# My Submission to Northern Beaches Council

Attention: Thomas Burns Planner Re: Mod2020/0715 - DA2018/0612  
7 Pavilion Street, Queenscliff

New Sutter as per approval in DA2018/0605/MG-5110

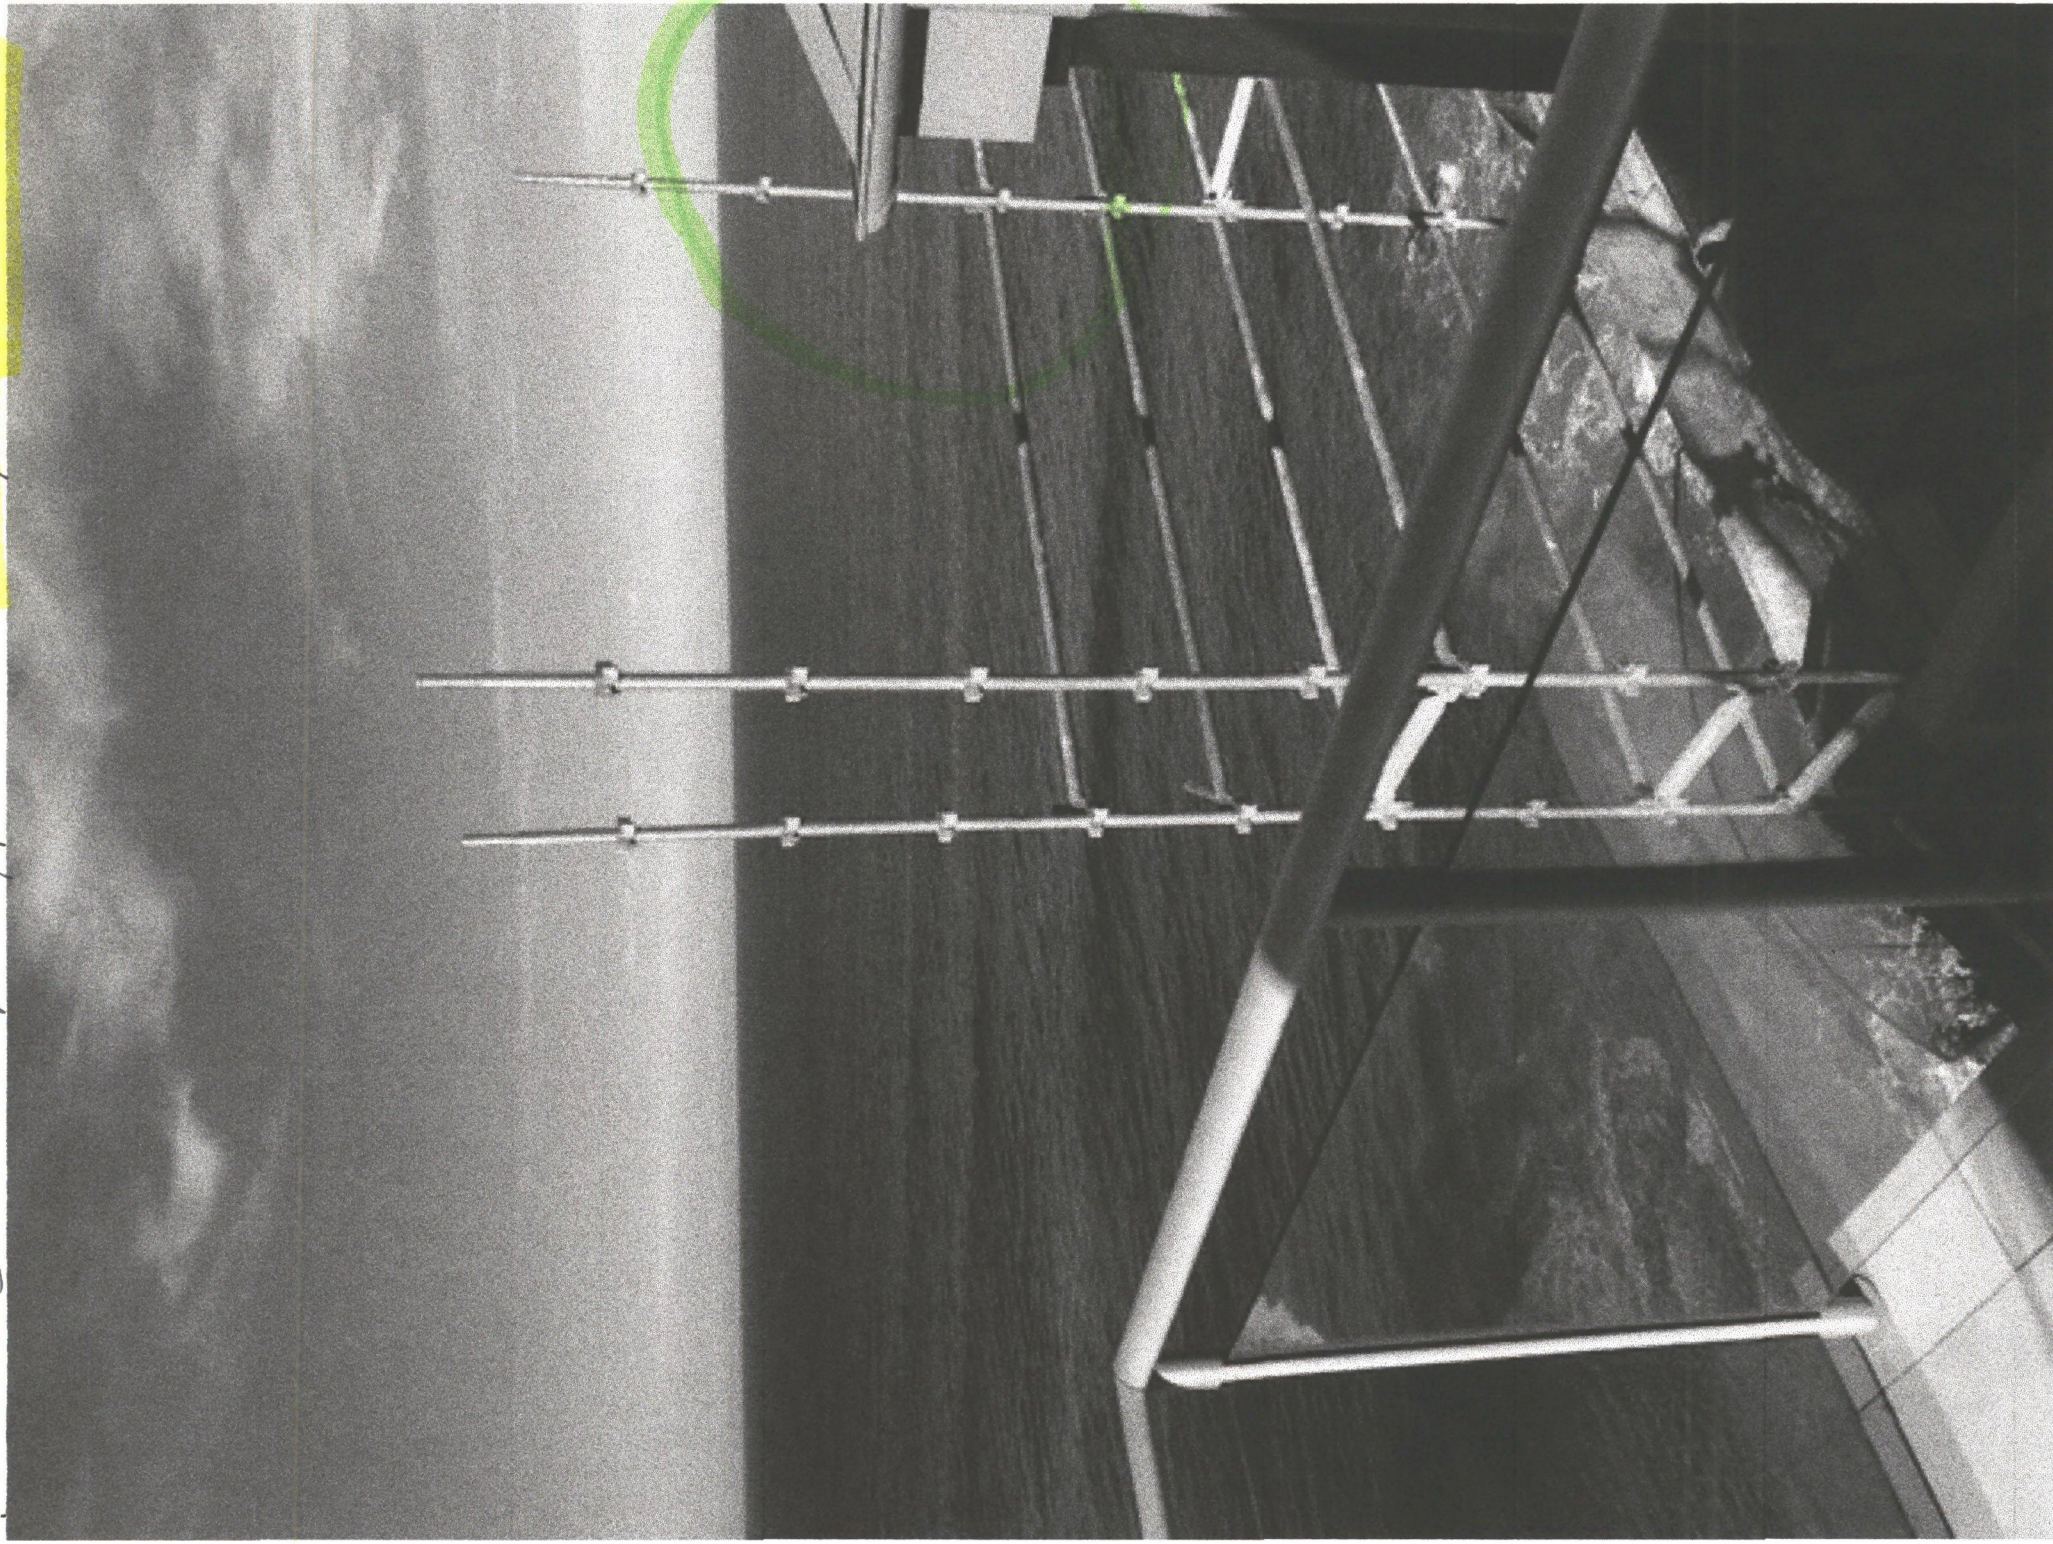
With regard to the Nolan Planning diagram in this MOD2020/0715, the 2 highlighted areas are not correctly drawn, as the roof and gutter were built (IMG 5110), and later a new scaffold was constructed to add the box like ceiling structure that now exists built out to the East from that gutter, IMG 5264 taken 18/5/20.

Extension of LV12 Bakery, Courtyard, Steps & Pavement to cliff 1MC 6529 Nov 20

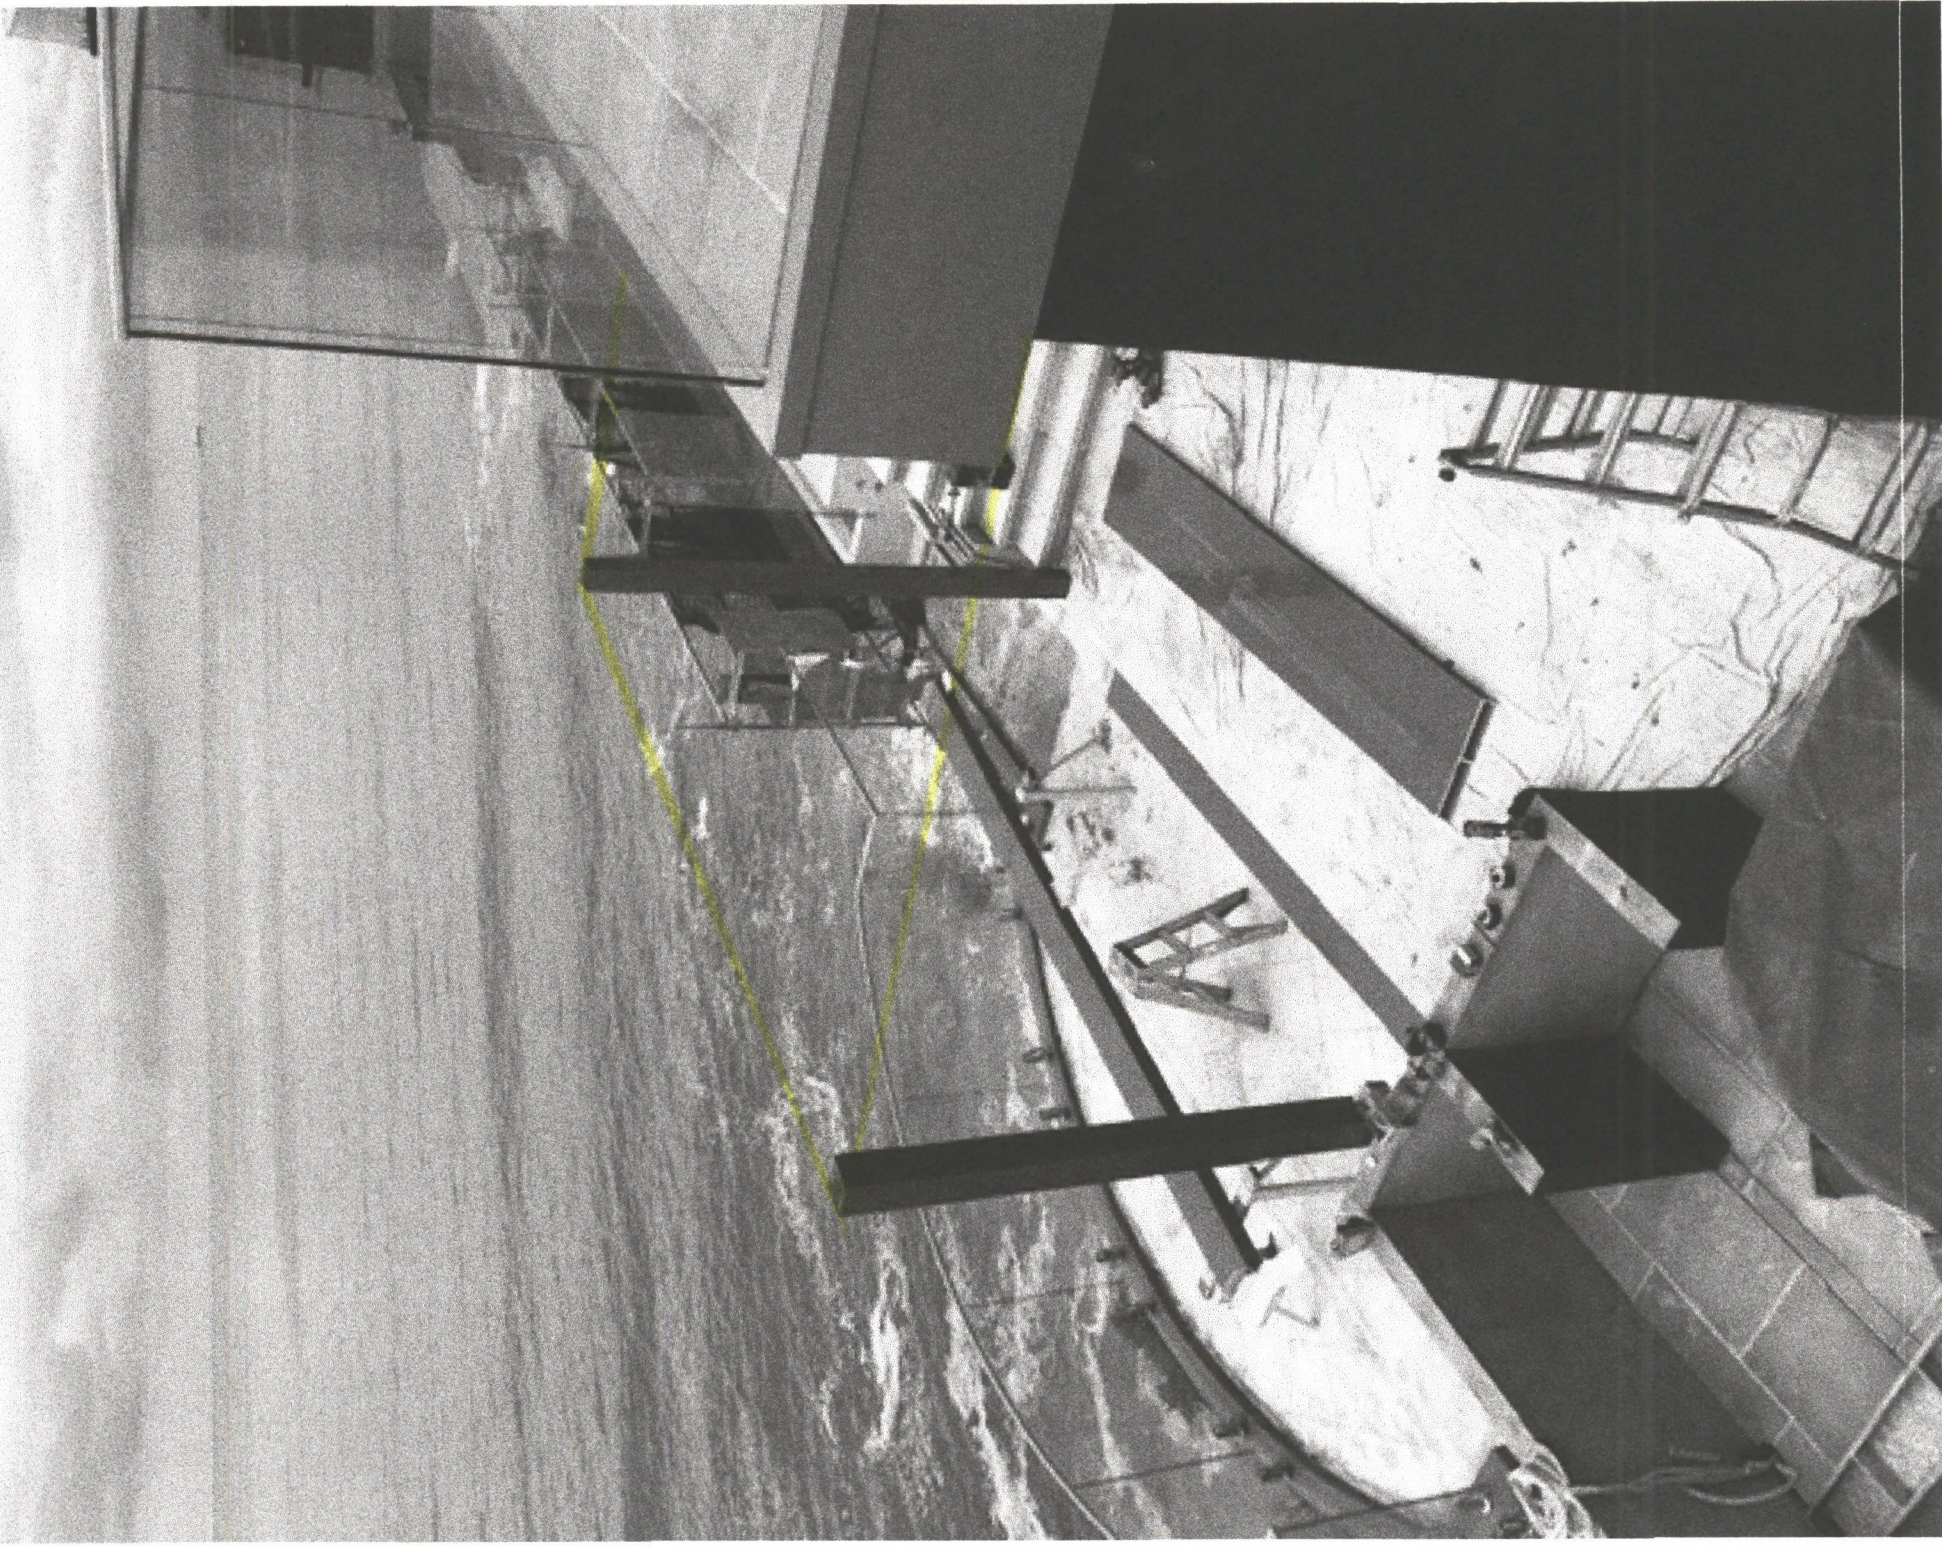
IMG 5496 & 6529 show the rebuilding of the steps down to the circular balcony area which have moved closer to the cliff edge and the construction of the new outdoor kitchen larger and closer to the cliff edge. The positioning of the pagola posts closer to the cliff and taller than originally, which sit directly in our living room views. The approved plans state "replace existing pergola" and MOD 0173 calls it an 'operable roof'. This pagola is not built to scale as per the approval.
